REPORT ON CABLE INSTALLATION

MIDLAND PLANT UNITS 1 AND 2

BECHTEL POWER CORPORATION

REPORT ON CABLE INSTALLATION  
MIDLAND PLANT UNITS 1 AND 2

SK 20  
Midland Plant Units 1 and 2  
Attachment 3 to  
Report on Cable Installation

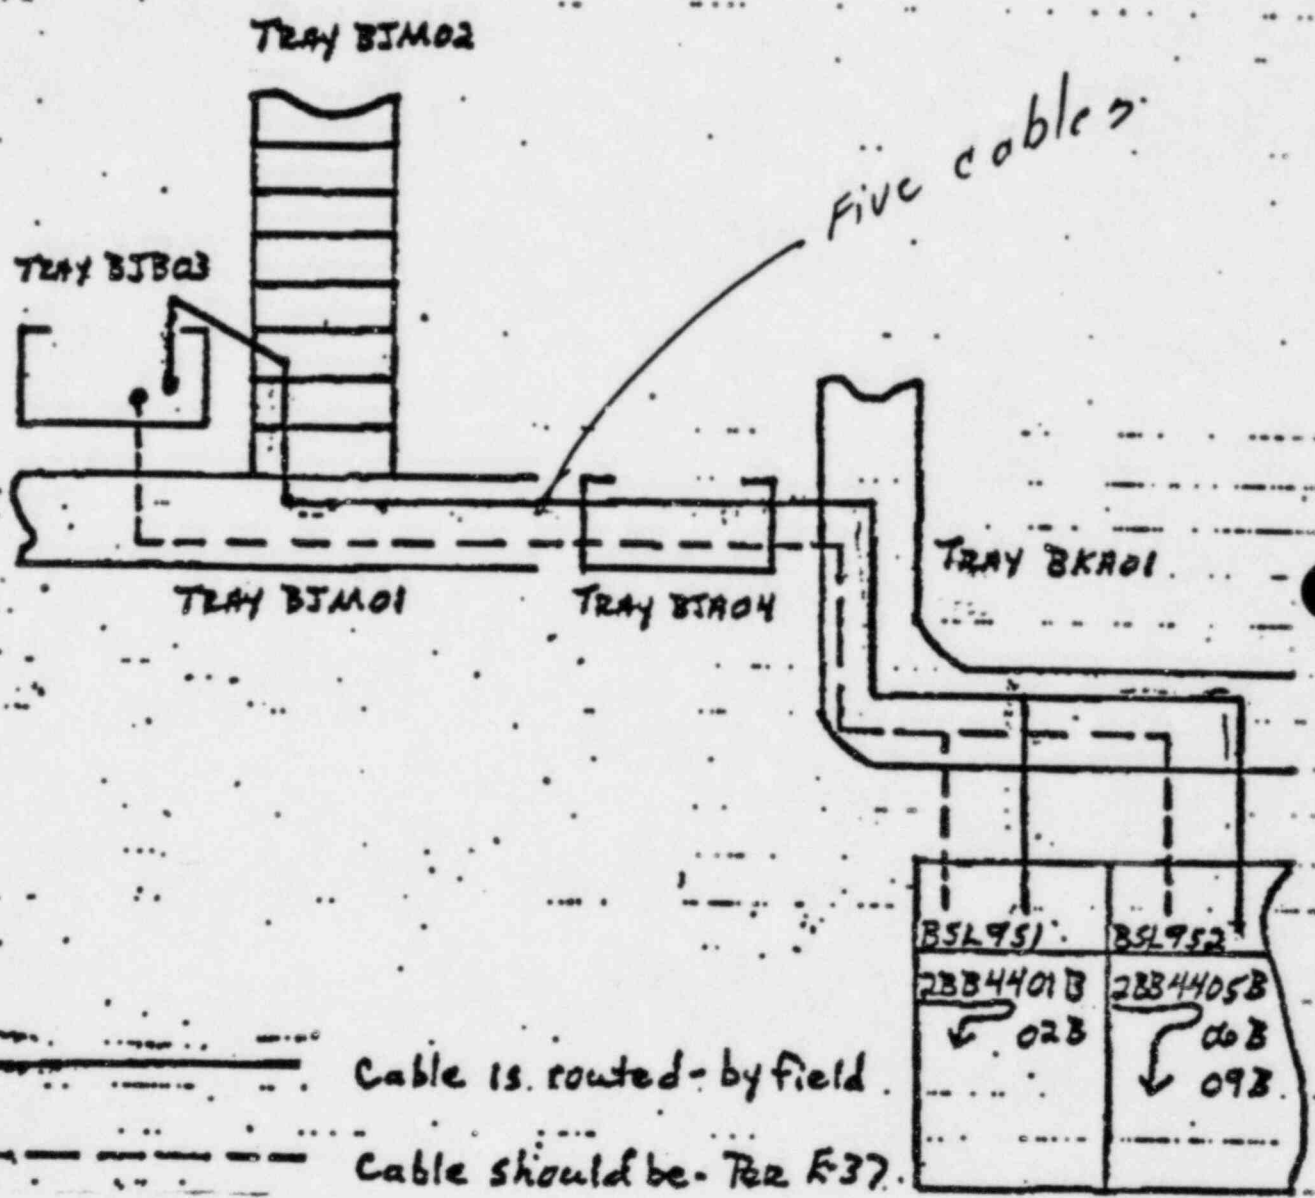
Cables were pulled into trays AKA06 and AJA06, which were listed as vias in E37, without engineering's knowledge.

Accountability; i.e., not knowing where a cable is pulled. This problem may have an adverse affect on thermal analysis.

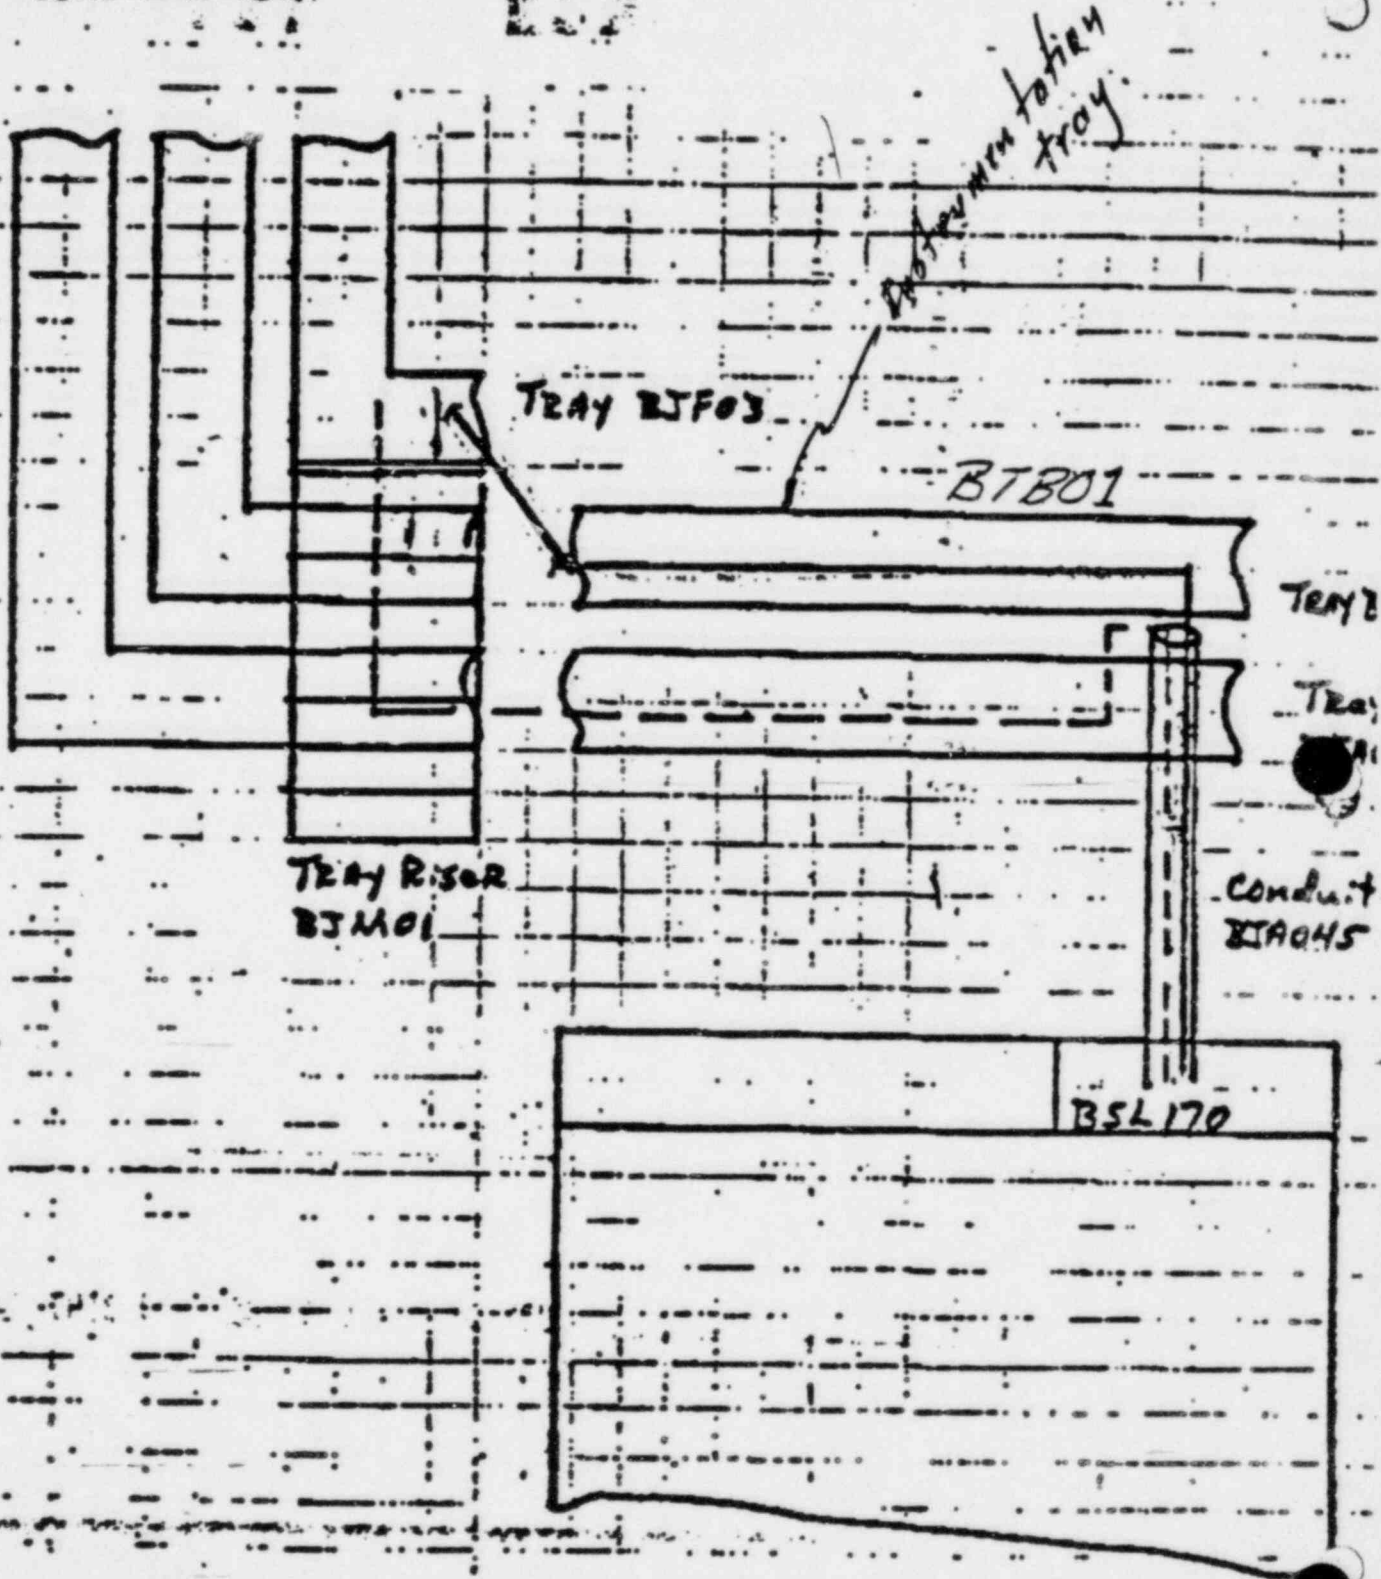
Accountability; i.e., not knowing where a cable is pulled. This problem may have an adverse affect on thermal analysis.

When a tray is wrapped, heat generated from cables in the tray must be taken into consideration. If a cable were pulled into that tray and engineering was not aware of it, the thermal analysis would not include that cable.

SK-25 Unique Case

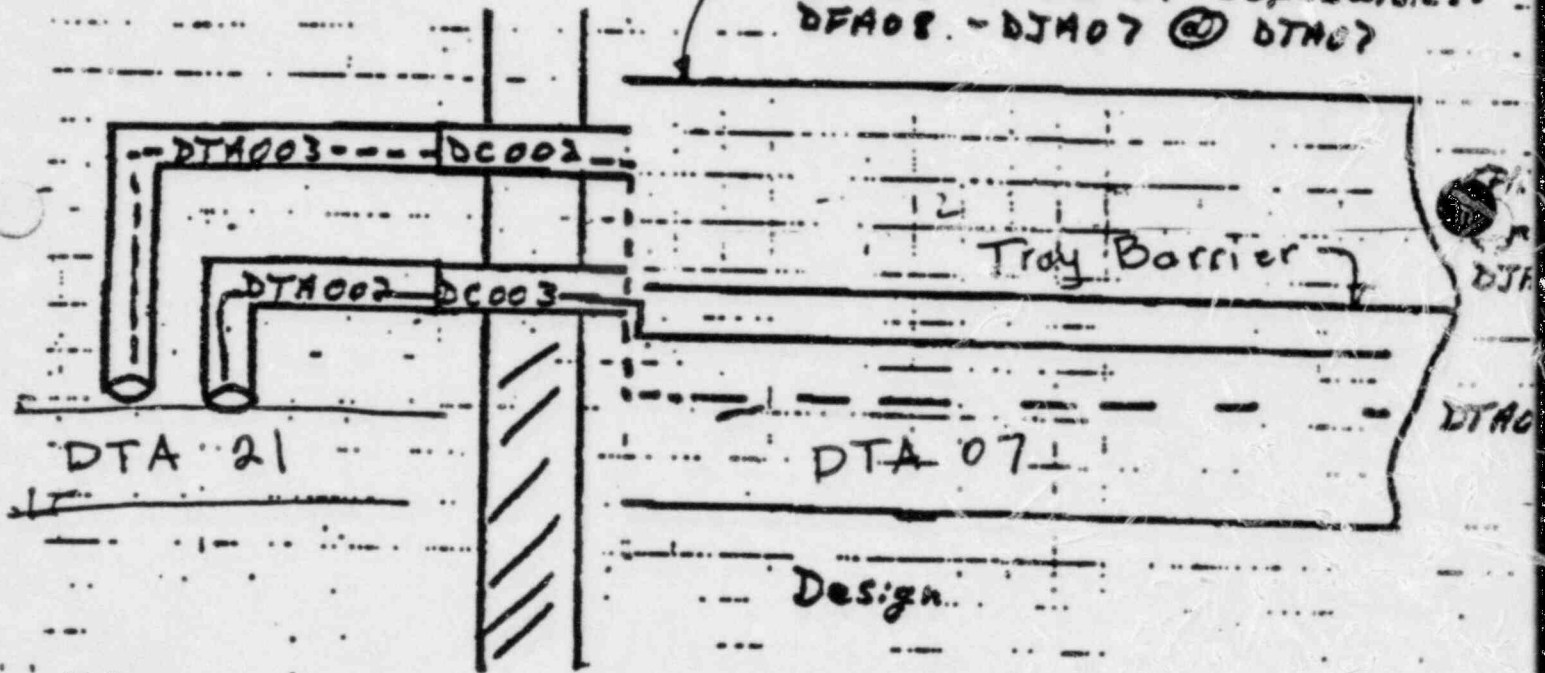
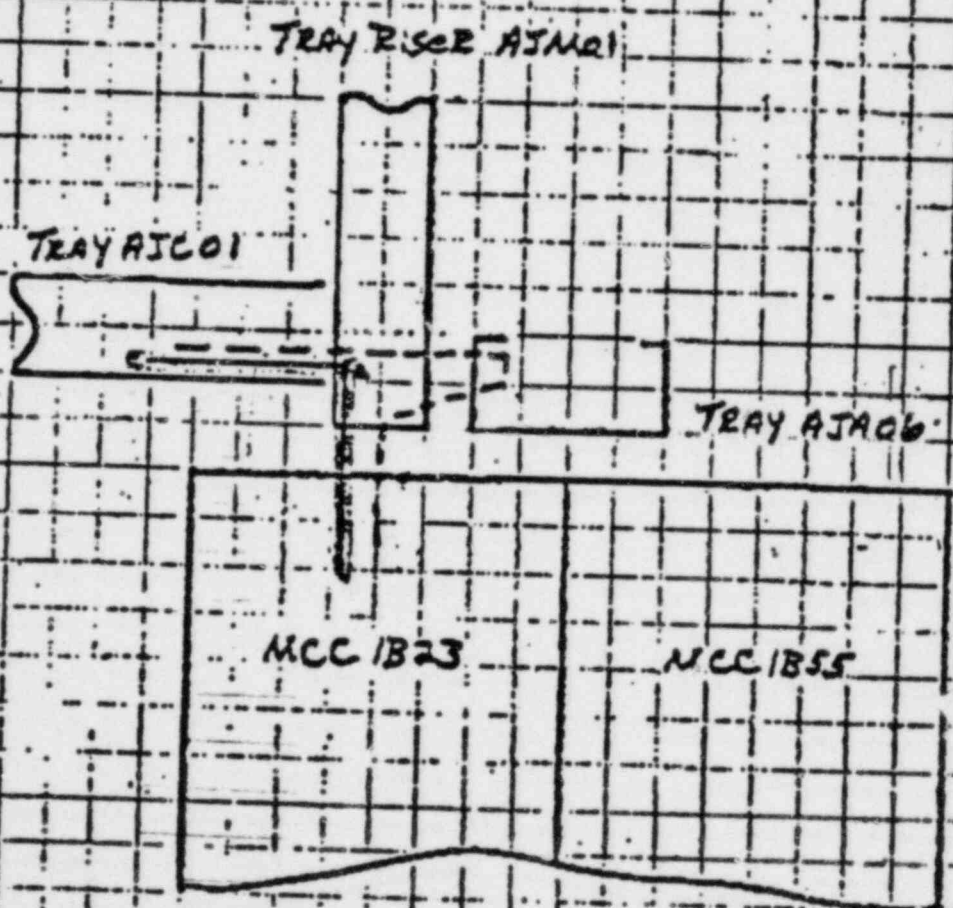
Troy Construction  
CROSS OVER OF SEPARATORS  
DTA08 - DJA07 @ DTA07

Sixteen small instrument cables were pulled into the wrong conduit.
